Sunlight Peak Community Solar Garden Site Plan

SUNLIGHT PEAK PHASE 1A AND 1B Site Plan *
(Official Project Name)

Cover Sheet

**PRELIMINARY HS25 PAVED ACCESS ROAD CROSS SECTION (PER
TABLE 5.01.2.03.2 INDUSTRIAL USE WITH CLASS C SOIL)**

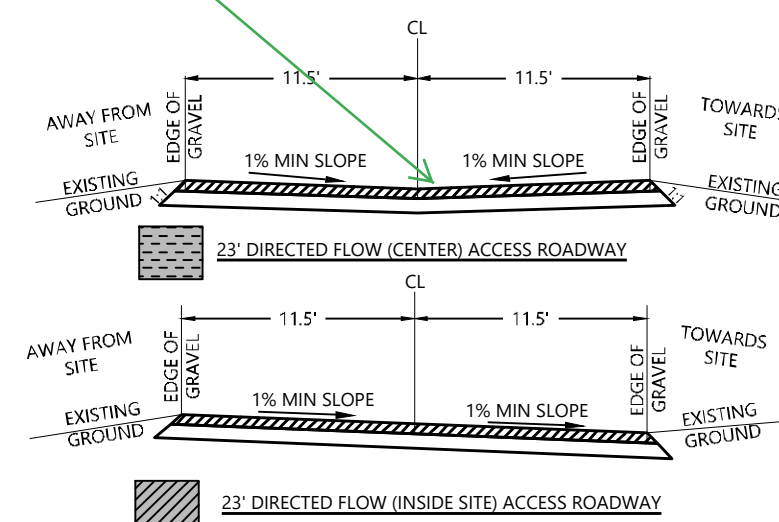
A V section is problematic for a gravel roadway. A pan would be required to convey flows without washing out the road, or provide a crown section, typical

Please indicate on the plans where each section is applied, typical

SIGHT TRIANGLES

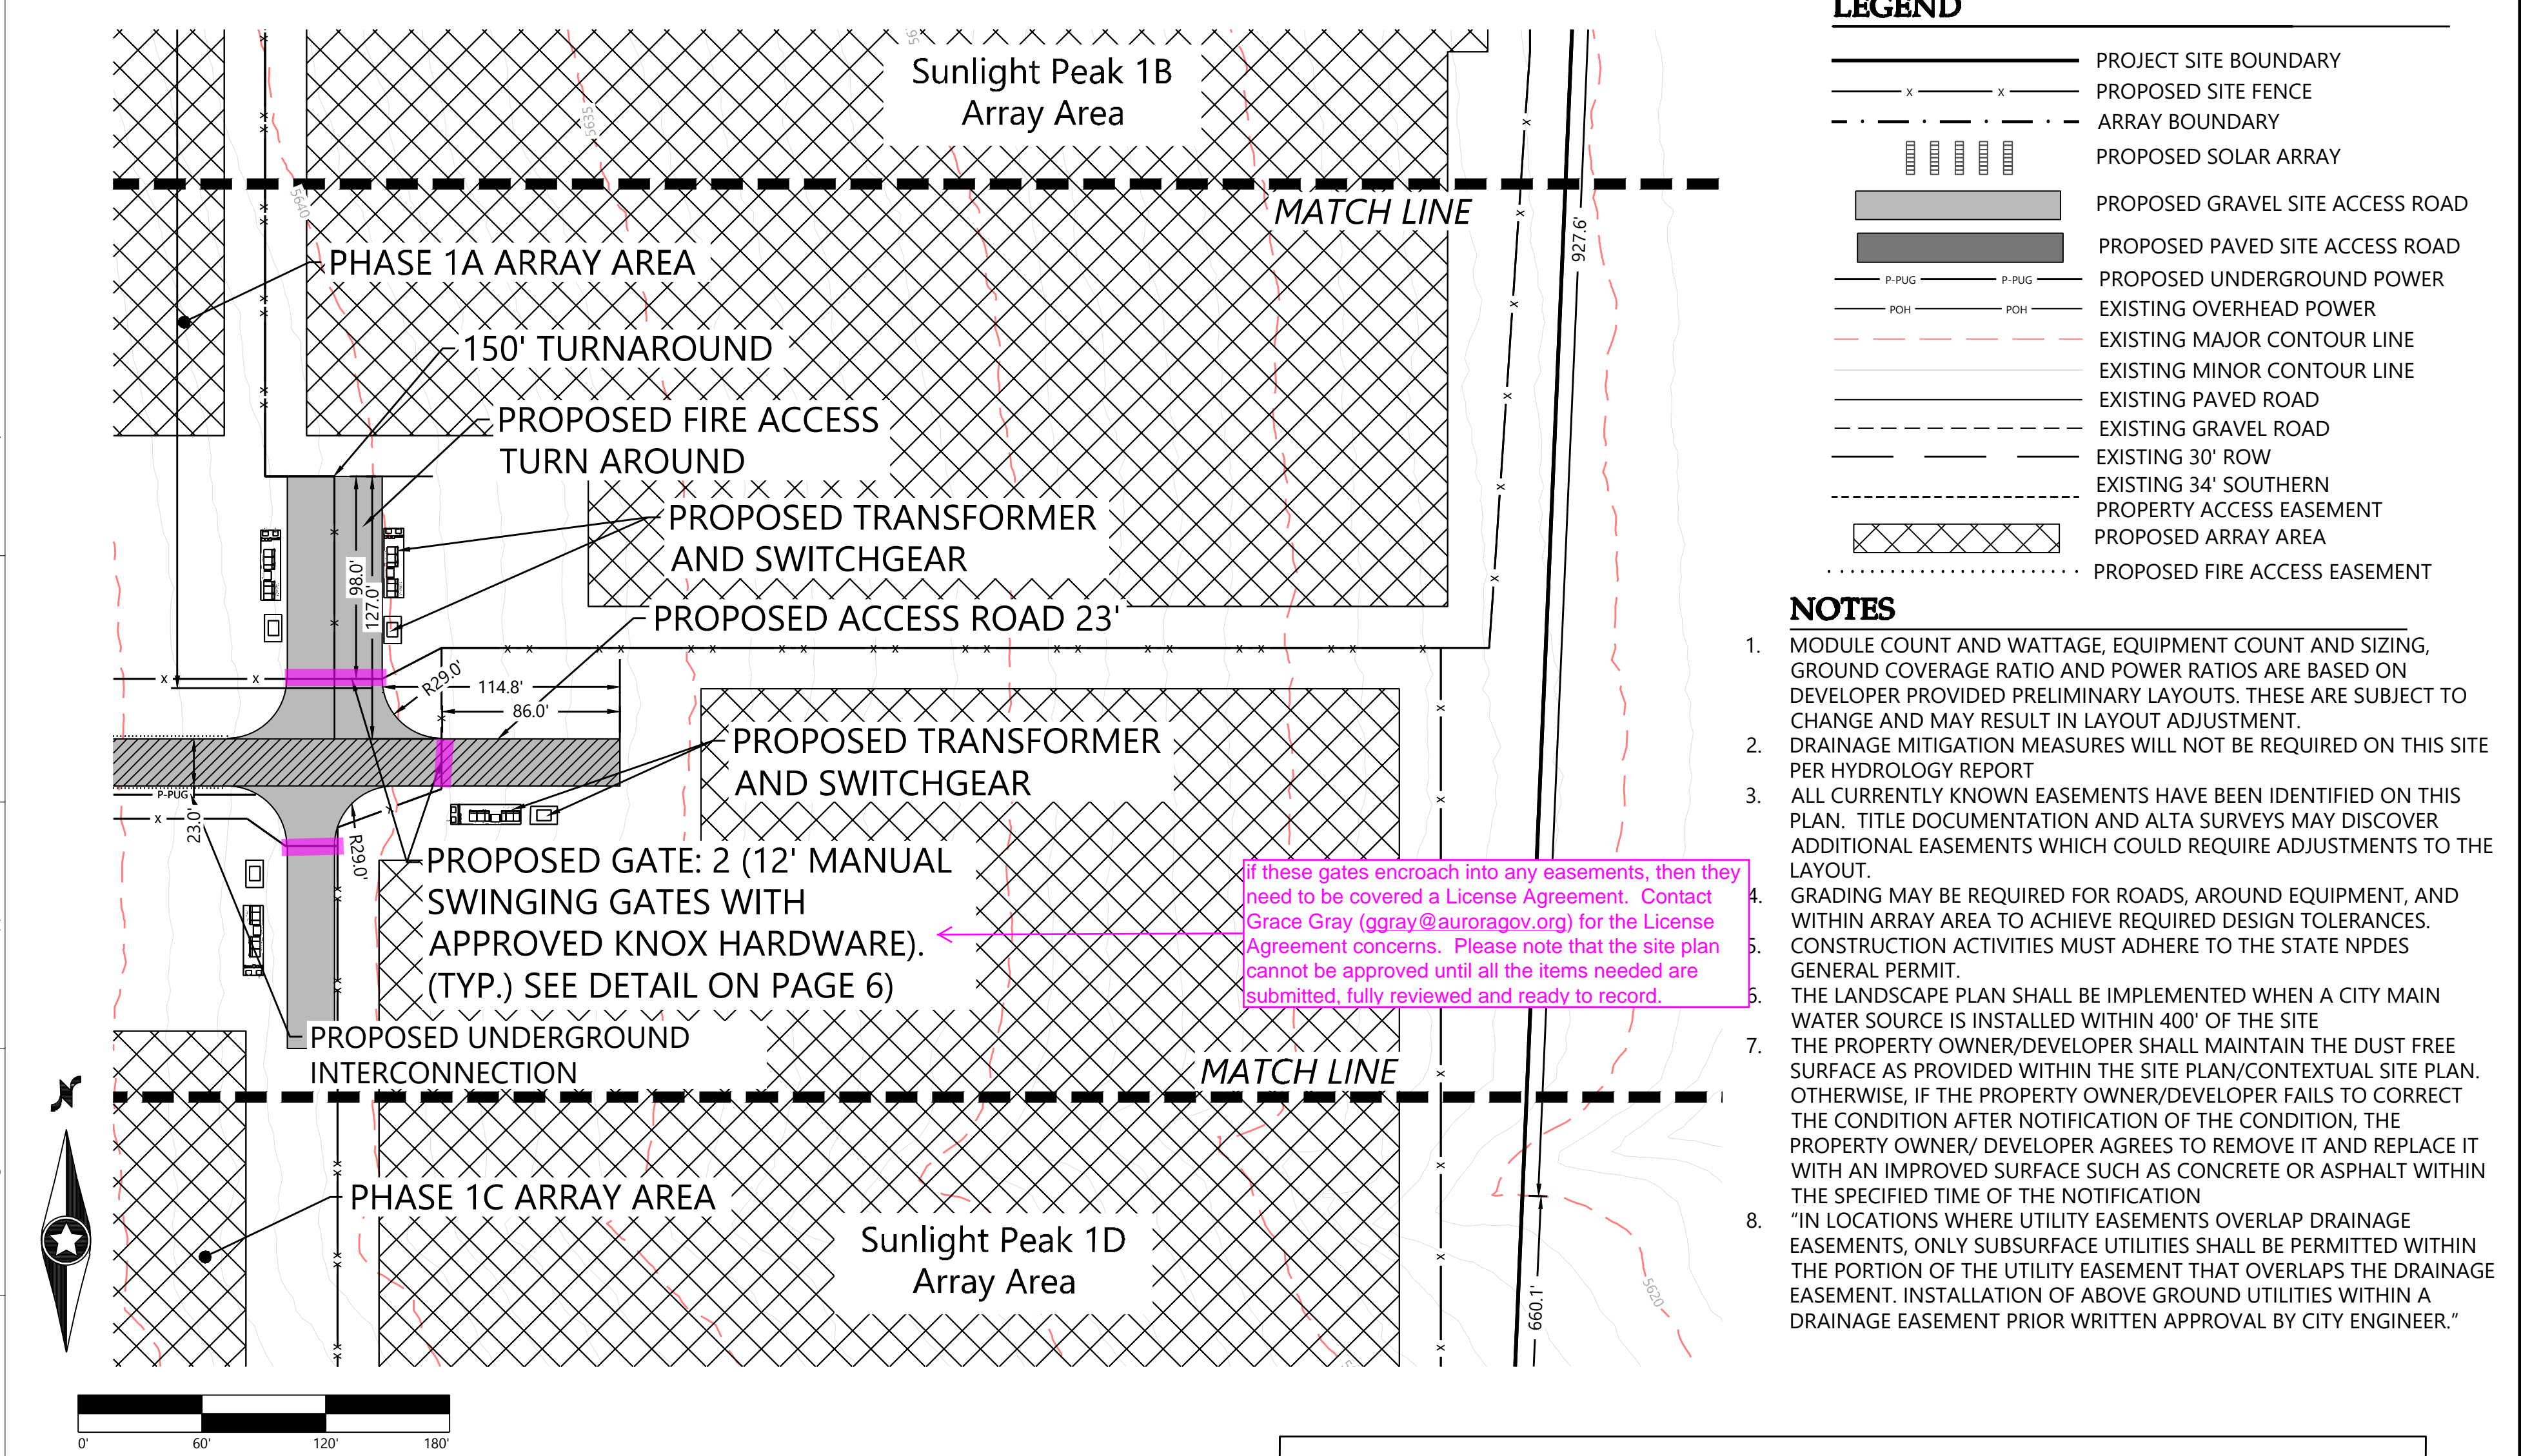
T TRIANGLES SHOWN ON PAGE 5
